Annex 1 – Legal Text

Changes shown in red text

SECTION K: TECHNICAL, DESIGN AND OPERATIONAL CRITERIA AND PERFORMANCE REQUIREMENTS FOR OFFSHORE TRANSMISSION SYSTEMS

Figure K3

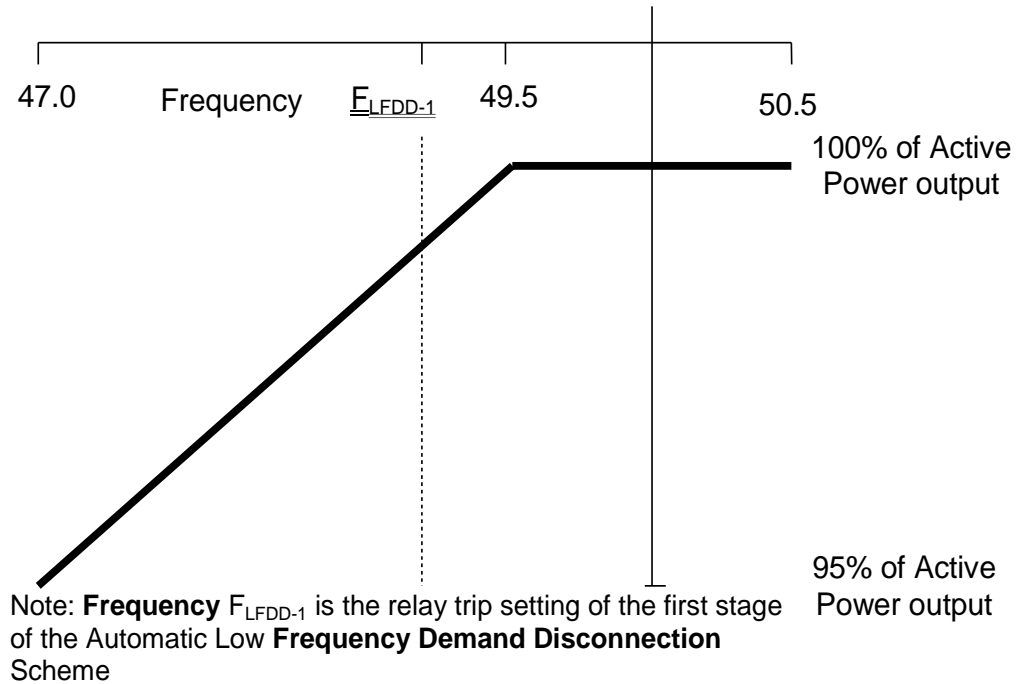
- (b) (subject to the provisions of Grid Code CC.6.1.3) maintaining its Active Power transfer at a level not lower than the figure determined by the linear relationship shown in Figure 2 for System Frequency changes within the range 49.5 to 47 Hz, such that if the System Frequency drops to 47 Hz the Active Power transfer does not decrease by more than 5%.

Figure K4

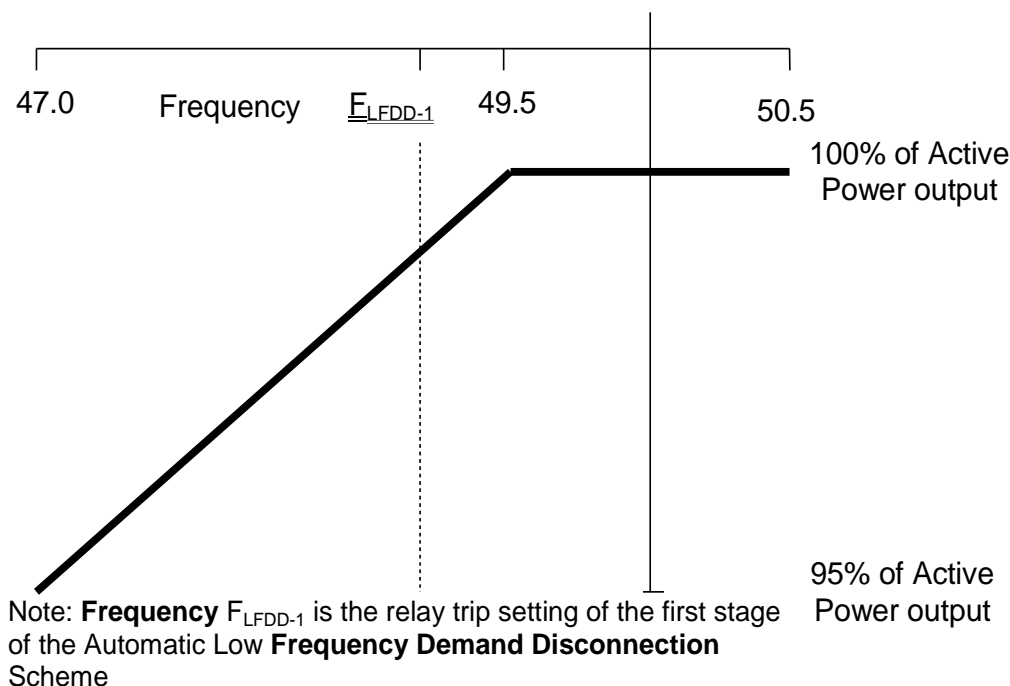
- (b) (subject to the provisions of Grid Code ECC.6.1.2) maintaining its Active Power transfer at a level not lower than the figure determined by the linear relationship shown in Figure K3 for System Frequency changes within the range 49.5 to 47 Hz,

such that if the System Frequency drops to 47 Hz the Active Power transfer does not decrease by more than 5%.
